U.S. NUCLEAR REGULATORY COMMISSION
REGION IV

Operator Licensing Exam Report: 50-285/OL88-03 Operating License: DPR-40

Facility Name: Fort Calhoun Station (FCS)

NRC Administered Examinations Conducted During The Week of July 26, 1988
(Report 50-285/OL88-03)

QUESTION 2.03/6.01

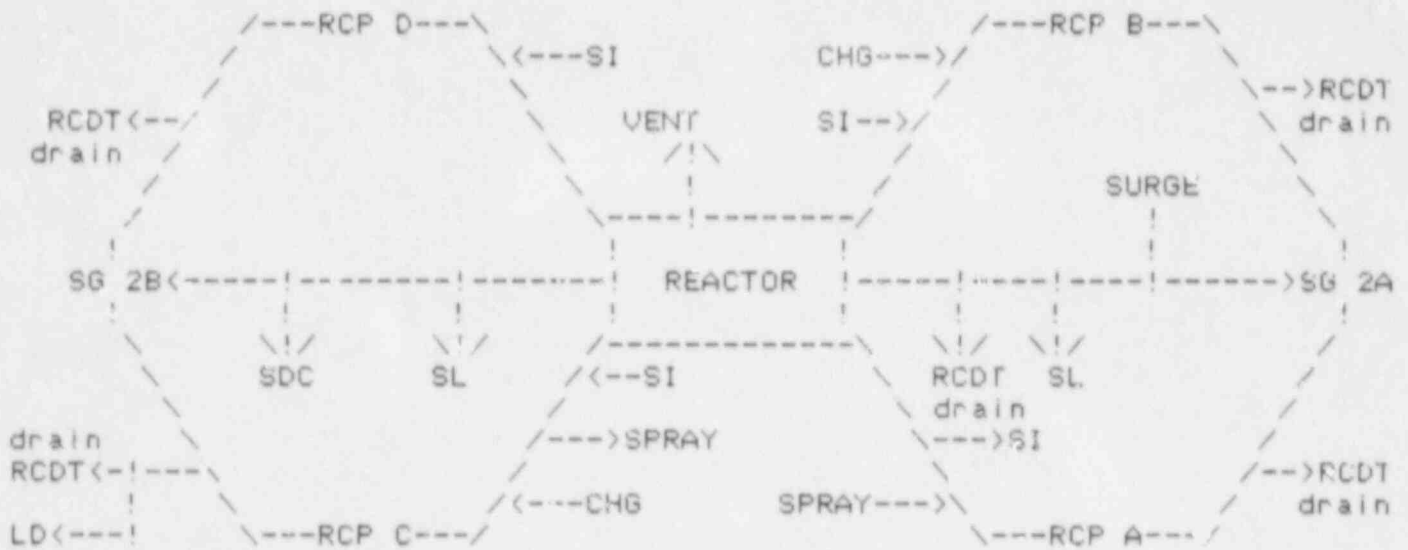
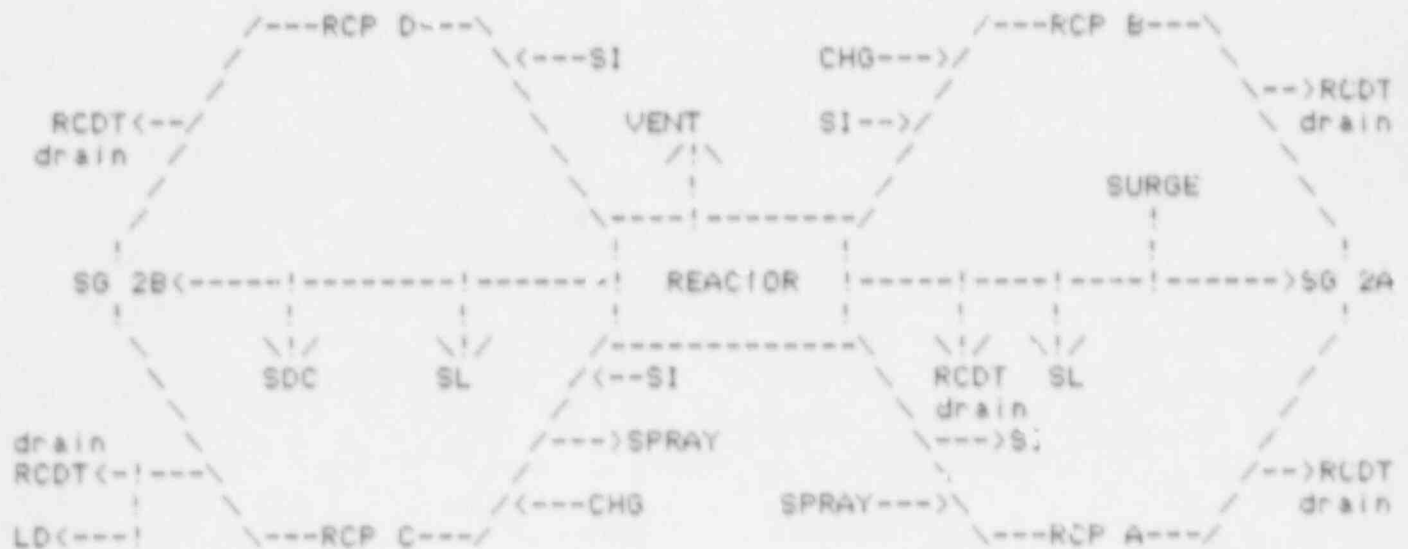
The drawing provided for the answer incorrectly shows the relative location of a few penetrations. Full credit should be allowed for responding as indicated on the attached drawing.

Reference: Marked-up copy of answer 6.01 and P&ID E-23866-210-110
